INFORMATION LETTER

429-17-03 11 September 2017 Revision A, 16 February 2022

SUBJECT: CURTISS-WRIGHT SERVICE BULLETIN D51615-31-19 REPLACEMENT UNDERWATER LOCATOR BEACON (90-DAY) KIT PART NUMBERS 112470, 112813 or 112814

Figure 2 – 90-Day Beacon Mounting Arrangement

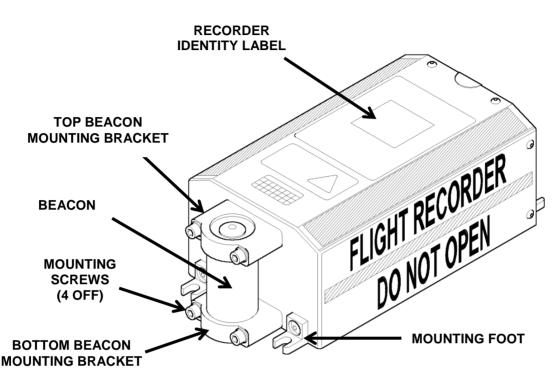
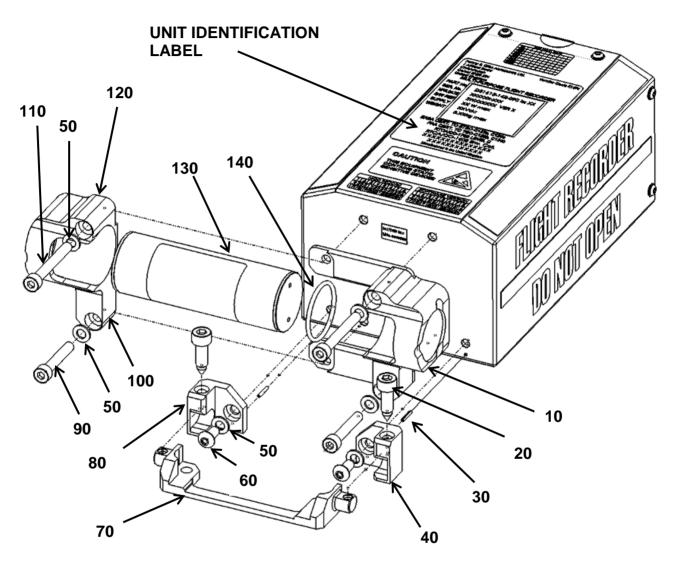
The new 90-day beacon is approximately 1 inch (25mm) longer in length than the existing 30-day beacon currently in use. As a result, the mounting brackets which secure the beacon to the recorder have been re-designed and the beacon mounting arrangement has been rotated by 90 degrees to fit the existing size envelope of the recorder unit and beacon combined.

To accommodate the new beacon mounting arrangement, it has been necessary to amend the design of the rear mounting feet of the recorder to aircraft structure as follows:

The two existing mounting feet attached to the recorder outer casing have been replaced by two (handed) foot fittings attached to the recorder rear casing using the existing screw locations.

The recorder is secured to the aircraft structure with a retention plate which is mounted on the aircraft structure and secured to the two new foot fittings on the rear of the recorder by two cap-head screws.

- 1) Using screws (60), washers (50) & Pins (30) fit recorder retaining foot fittings (40) and (80).
- 2) Apply Loctite 222 (locally sourced) to the threads and torque tighten screws to 2.8-3.0Nm

- 3) Secure the RH bracket assembly (10) to the recorder using one of the longer fixing screws (110) and washers (50) in the upper location.
- 4) Secure the RH bracket assembly to the recorder using one of the shorter fixing screws (90) and washers (50) in the lower location.

- 6) Fit the Silicone rubber cord (140) into the bore of the appropriate mounting bracket into which the base of the beacon (130) is to be located (see Figure 2).
- 7) Slide the beacon into the bracket firmly up against the rubber cord.
- 8) Secure LH bracket (120) to the recorder using screws (90), (110) and washers (50). See steps 3 & 4 above.
 - <u>Note</u>: Apply a small amount of Loctite 222 (locally sourced) to both screws before tightening.
 - <u>Note</u>: Ensure all beacon mounting bracket parts are correctly located before tightening the mounting bracket retaining screws (90) & (110) to 6.5-7.0Nm.

- 1) Fit the retention plate (70) to the aircraft structure using two cap-head screws (6.35mm Dia.) and washers (locally sourced).
- 2) Locate the foot retention fittings (40) and (80) into the retention plate (70).
- 3) Apply a small amount of Loctite 222 (locally sourced) to the threads of the screws (20).
- 4) Secure assembly with the two cap head screws.
- 5) Torque tighten to 5.0-5.5Nm
- 6) Secure the existing recorder foot fittings (opposite end to the beacon) to the aircraft structure, (fasteners not supplied).
